2000-F12-SCM-EL-10213_Rev1

F12-SW-001 F12-FA-401 primary crusher 2 discharge apron fe schematic and termination diagram

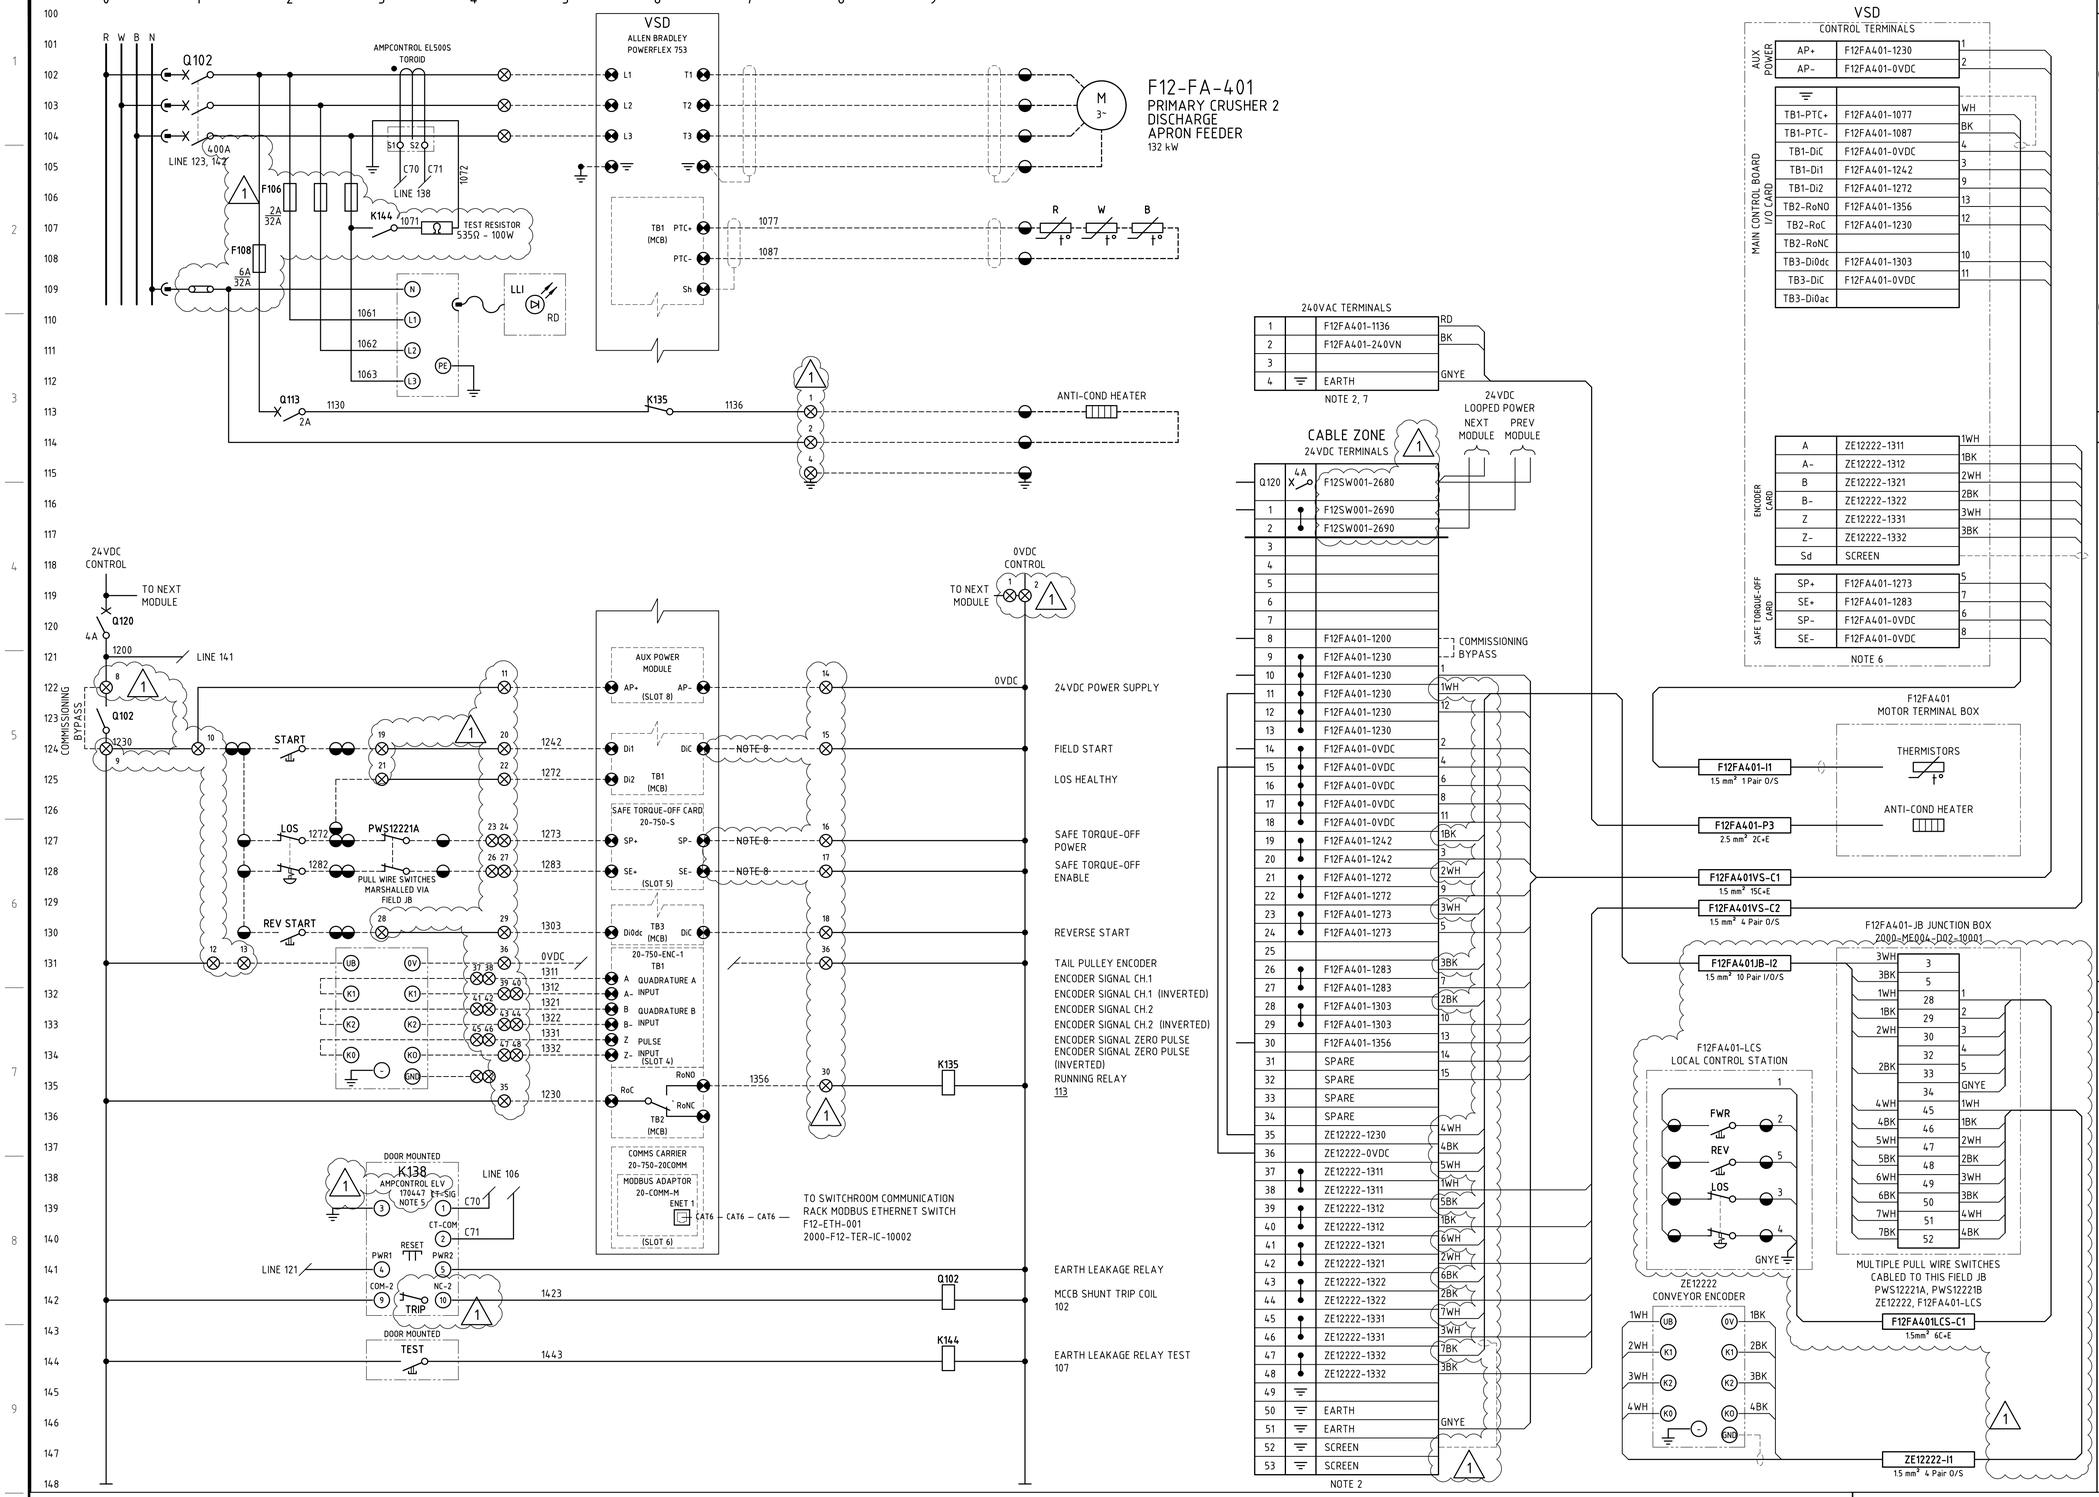
1. TERMINALS ON TERMINAL STRIPS ABOVE 50VAC SHALL HAVE A SEPARATE PERSPEX SHROUD AND SHALL BE LABELLED "DANGER xxxVAC".
2. WIRE NUMBER FERRULES ON TERMINAL STRIP SHALL BE PREFIXED WITH EQUIPMENT NUMBER e.g. F12FA401-1200, UNLESS OTHERWISE NOTED. (1)
3. EACH WIRE SHALL BE IDENTIFIED AT BOTH ENDS WITH FERRULES.
4. AMPCONTROL 101656 100/1A TOROID. (1)
5. EARTH LEAKAGE RELAY (ELV) USER INTERFACE TO BE MOUNTED ON MCC MODULE DOOR. RELAY ENERGISED (NORMALLY CLOSED CONTACT OPEN) IN NORMAL OPERATION.
6. VSD SHALL BE FRAME SIZE 5 AND ABOVE.
7. 240VAC TERMINALS FOR THE HEATER CIRCUITS SHALL BE LOCATED IN THE MCC DRIVE MODULE.
8. SITE TO MARK UP 0VDC LINKING IN THE VSD AS THE SWITCHROOM MANUFACTURER HAS NOT PROVIDE THIS WIRING DETAIL. (1)
